**Charleston Armory HVAC Renovations
And Architectural Improvements
DEFK - 9013**

Addendum No.: 3
Issue Date: May 19, 2009
Architects Project No.: 115063
Bid Opening: 1:30 p.m. May 28, 2009

From: **Michael Baker Jr., Inc.**
5088 Washington Street, West
Charleston, West Virginia 25313

Drawing Title:
MECH & ELECT SCH

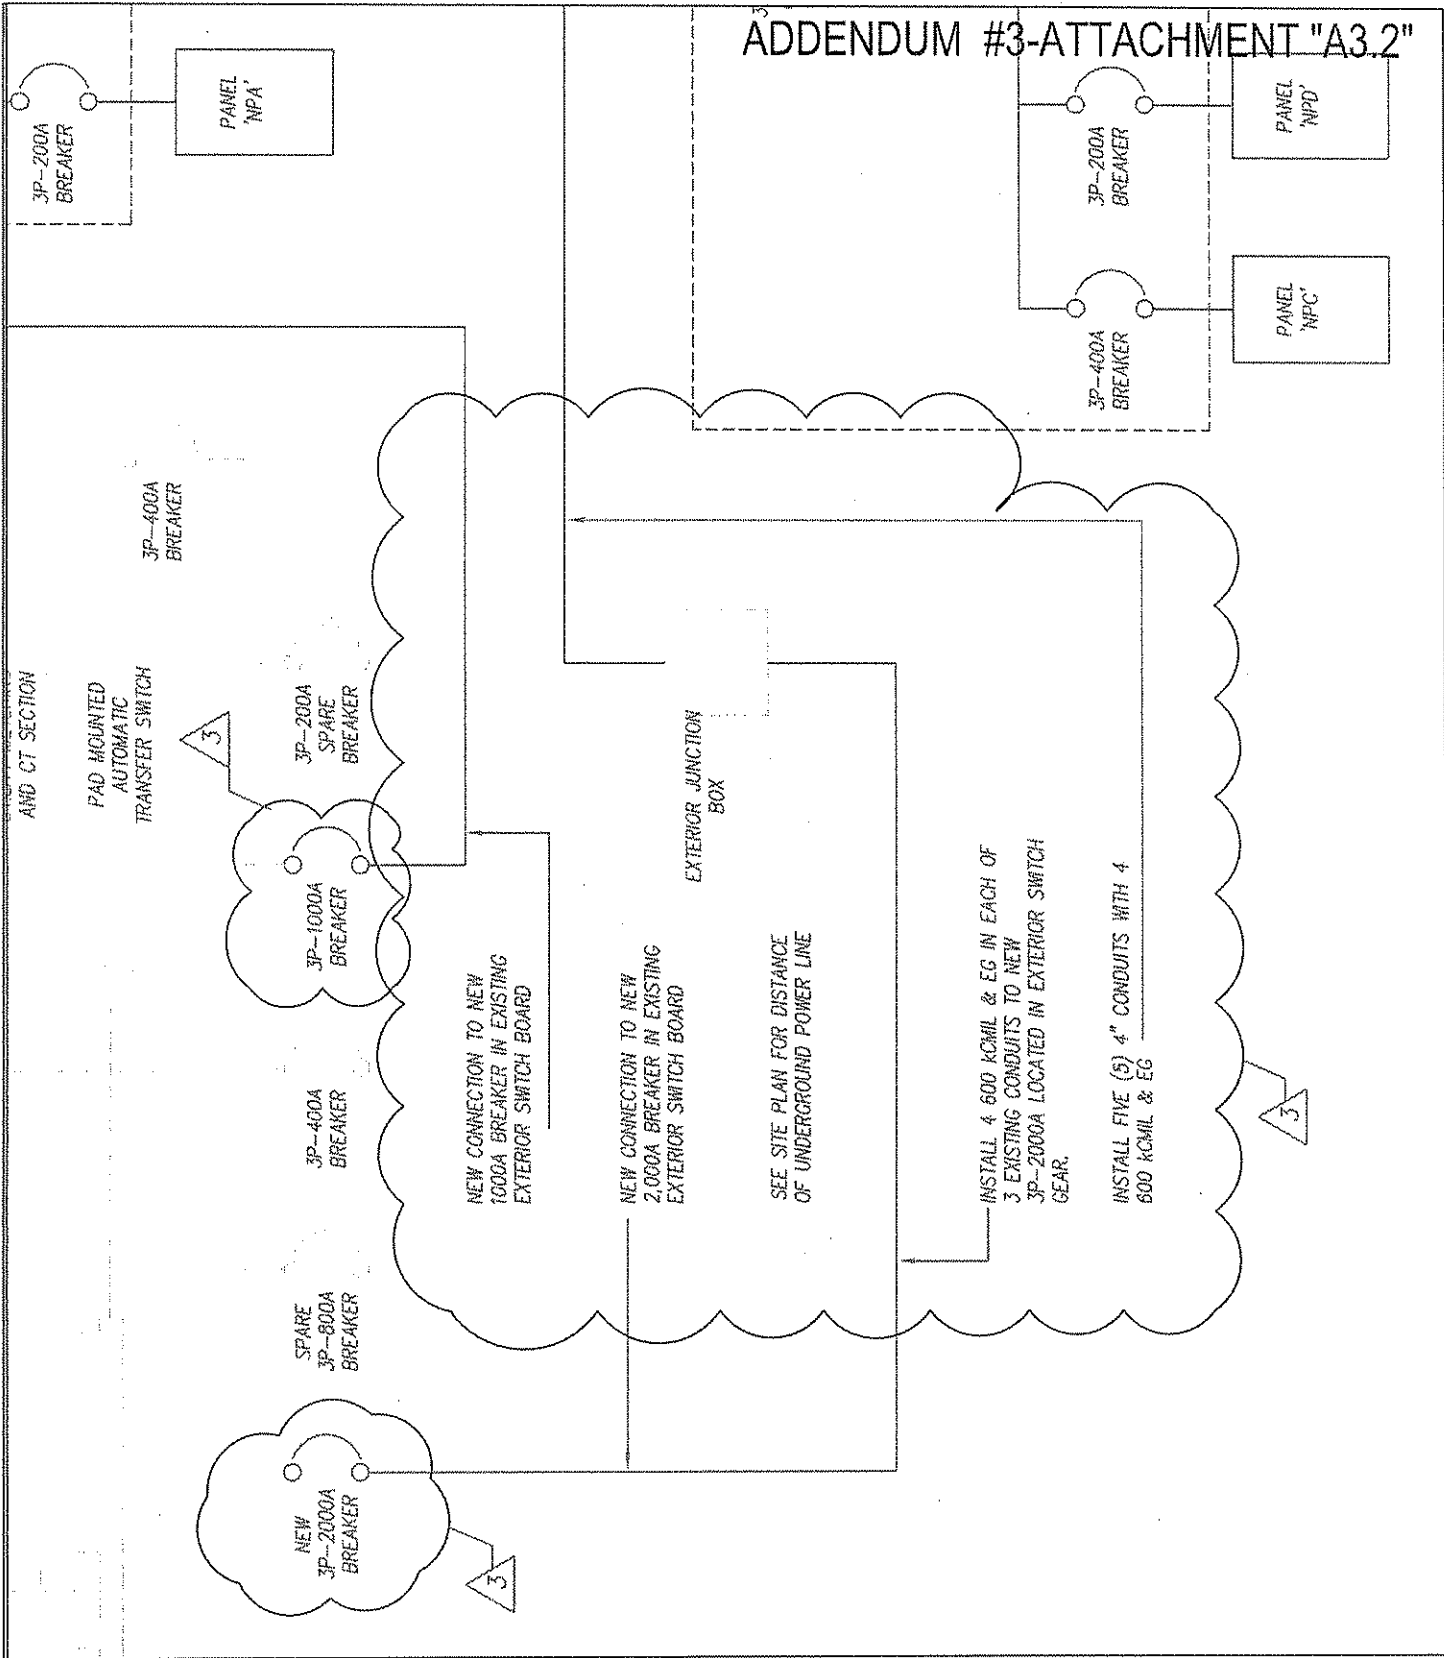
5. REVISE the PUMP SCHEDULE on drawing M0.2 as per attachment "A3.1".
6. REVISE: Drawing M0.3 Loop Water Piping Schematic (Alternate 1 & 2) as follows:
Change BLR-1 & 2 to BLR-3 & BLR-4, respectively. Pipe sizes remain the same for each system.

9. ADD Lighting Schedule to Drawing E0.1 as per attachment "A3.1".
